**RE: Dominion North Anna Power Station Unit 3
Part III-Major Surface Water Withdrawal for Operational Activities and Lake Level Rise
Joint Permit Application No. 10-2001
Addendum 1, Response to Additional Information Request**

JPA No. 10-2001 Part III Operational Water Withdrawal

Addendum #1

DEQ Additional Information Request Letter; February 9, 2011

Figure 1

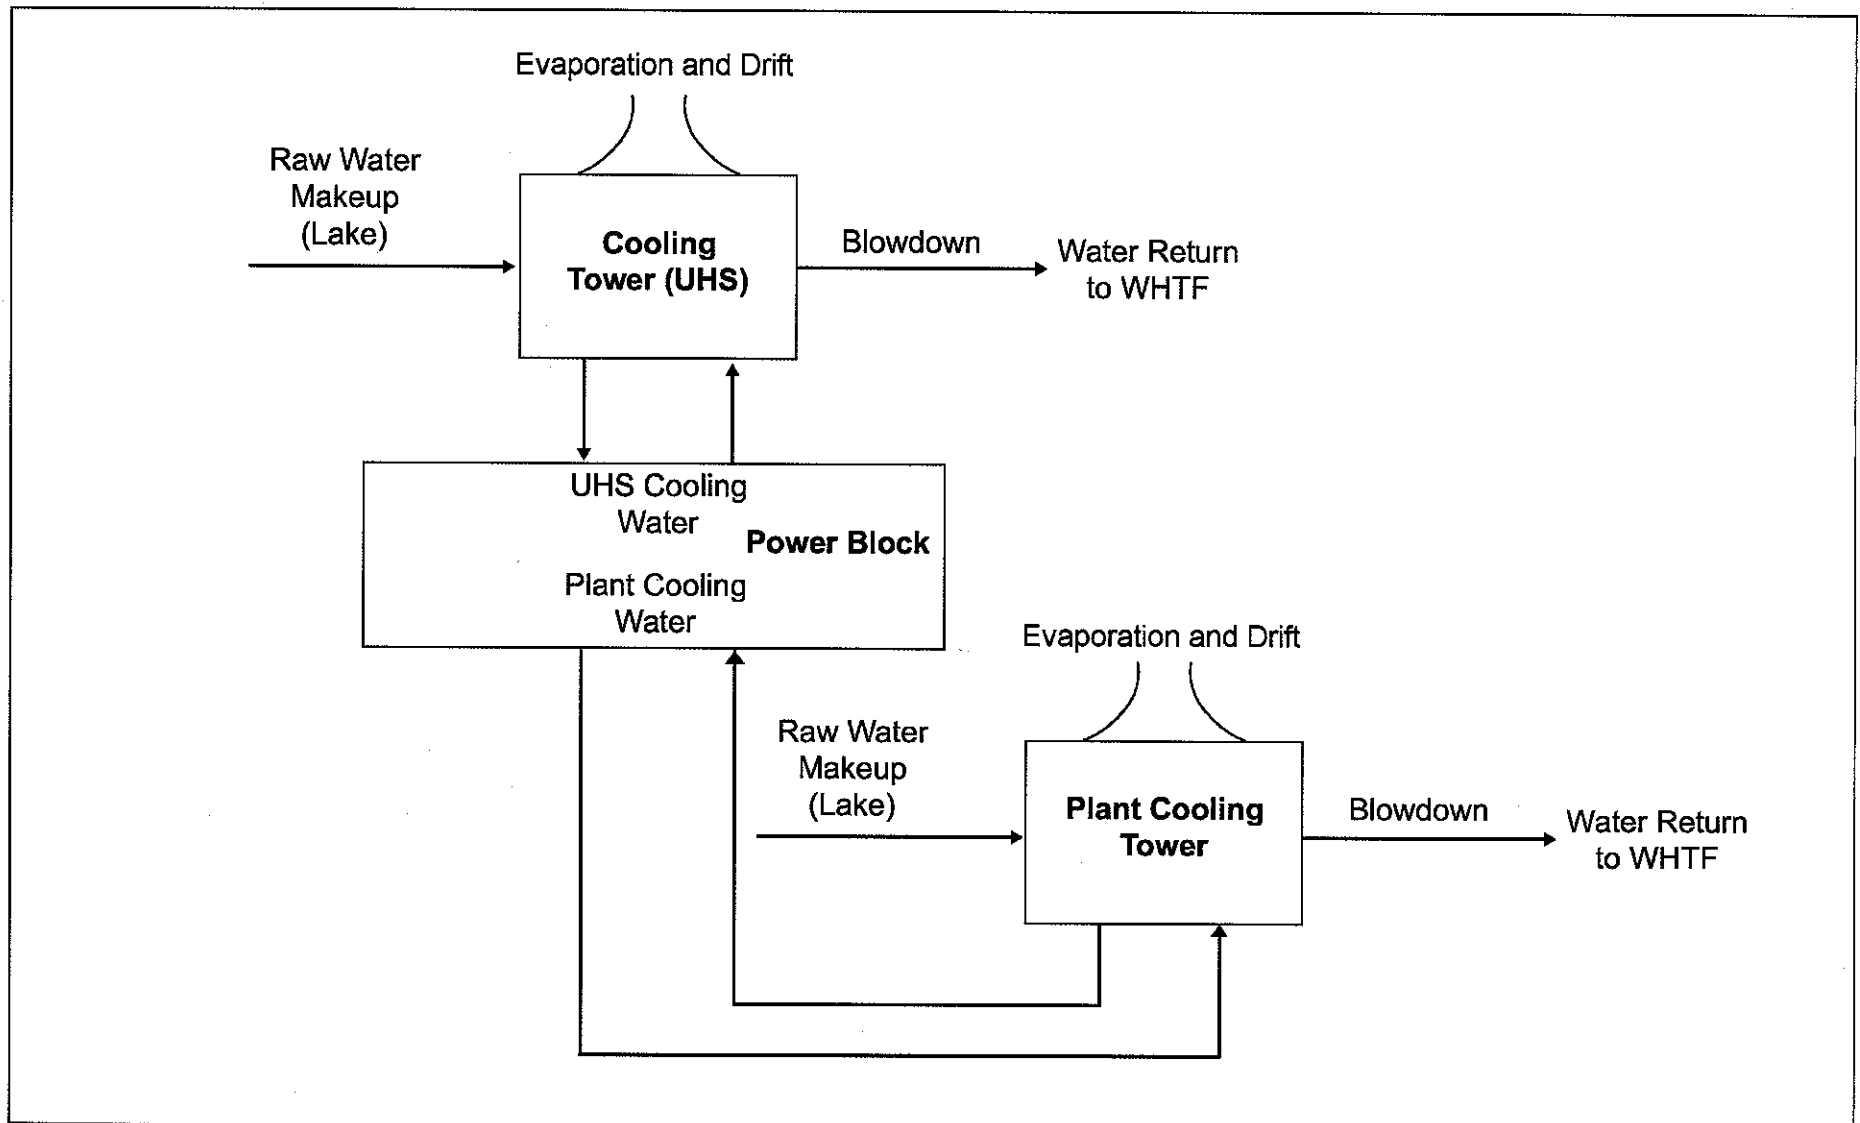
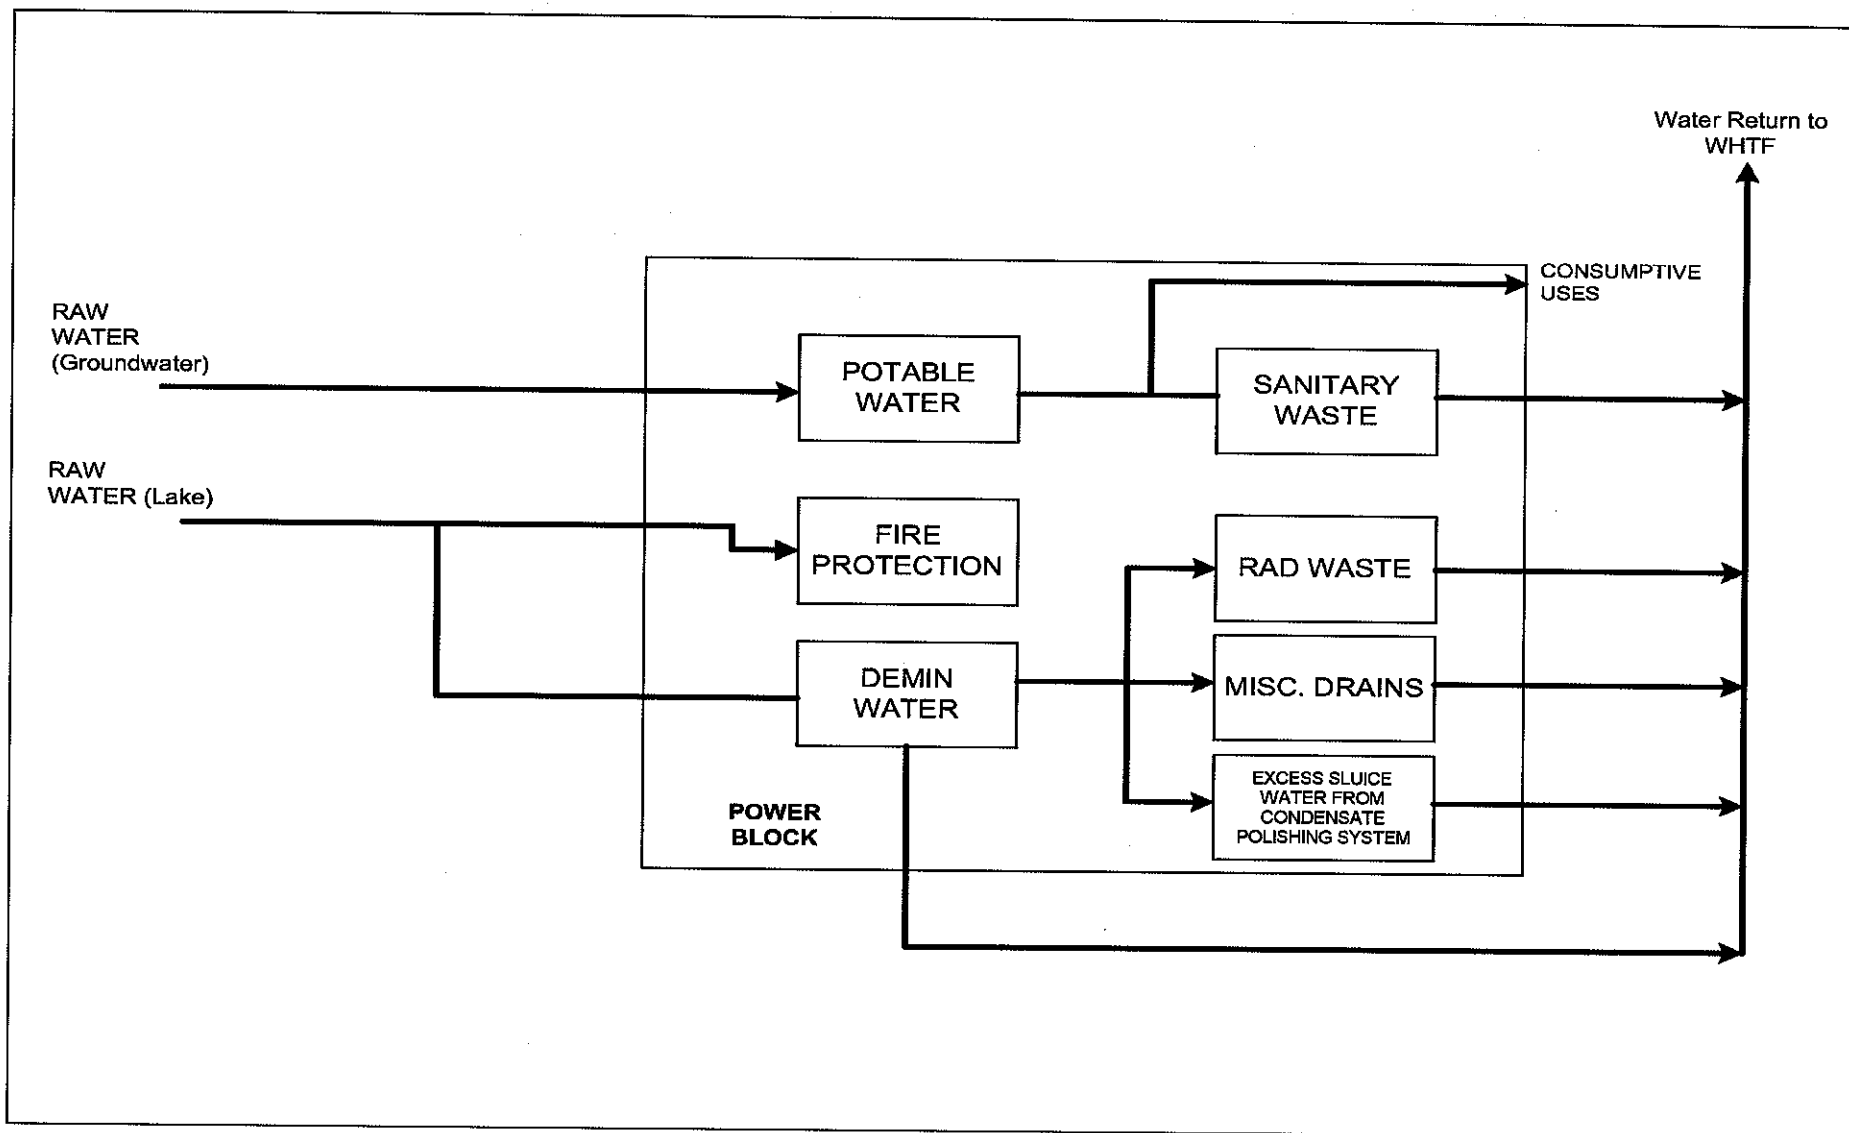
DEQ Question 1: Provide more detail as to how the withdrawal demand for each proposed withdrawal system was determined. In your discussion, provide the water budget upon which the proposed withdrawal volumes are based, including a diagram of each proposed withdrawal system depicting both inputs and outputs.

Figures 1 and 2 depict the general flow of water for the operation of Unit 3. Below is additional information regarding the estimated water withdrawal values presented in the December 2010 Joint Permit Application for Major Water Withdrawal and Lake Level Rise (JPA). The responses are provided for each system reliant on makeup water from Lake Anna; Circulating Water System (CWS) and Ultimate Heat Sink (UHS), Station Water System (STW) and Fire Protection Water Supply System (FSS); for the average daily withdrawal rate, maximum daily withdrawal rate and maximum instantaneous withdrawal rate.

Figure 3: Site Utilization Plan

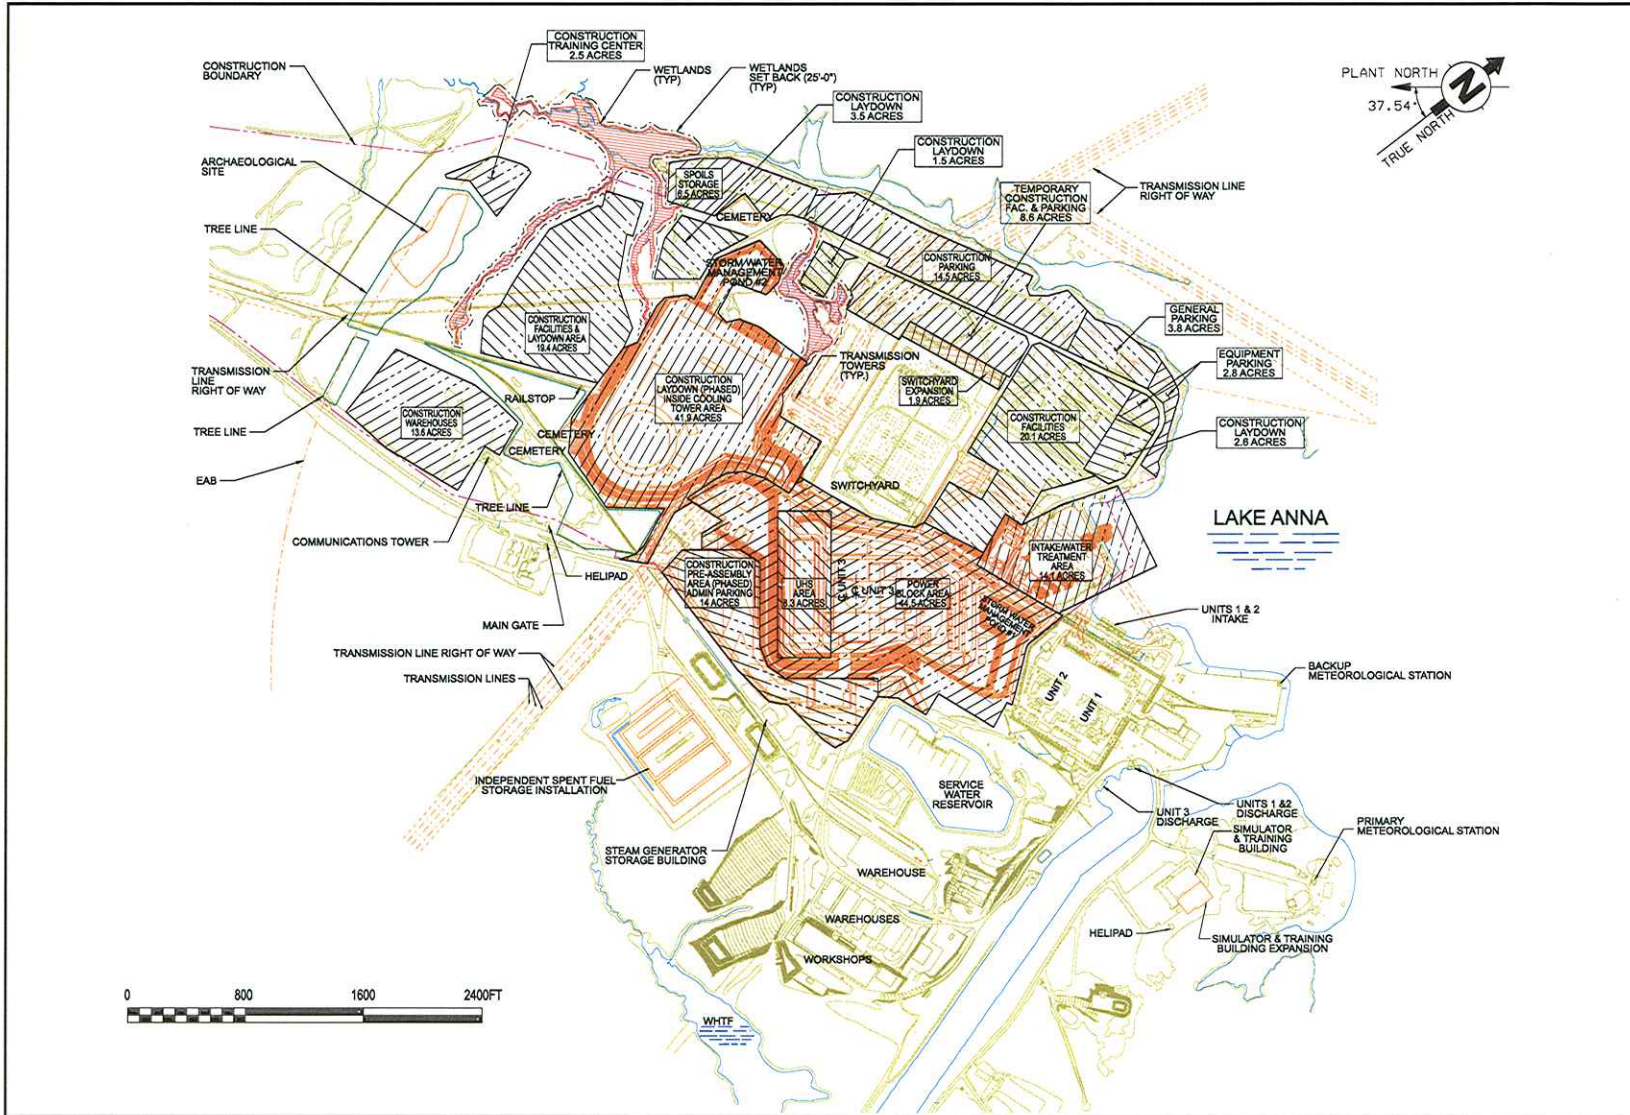
DEQ Question 6: Provide on a map indicating the location of the return flow (i.e. discharge) of the non-consumptive volume.

Attached (Figure 3) is a copy of the Site Utilization Plan, Figure 1.1-1, from the Combined License Application (COLA) ER, Revision 3. The figure illustrates the proposed Unit 3 infrastructure, including the proposed Unit 3 discharge location, as well as existing Unit 1 & 2 infrastructure.
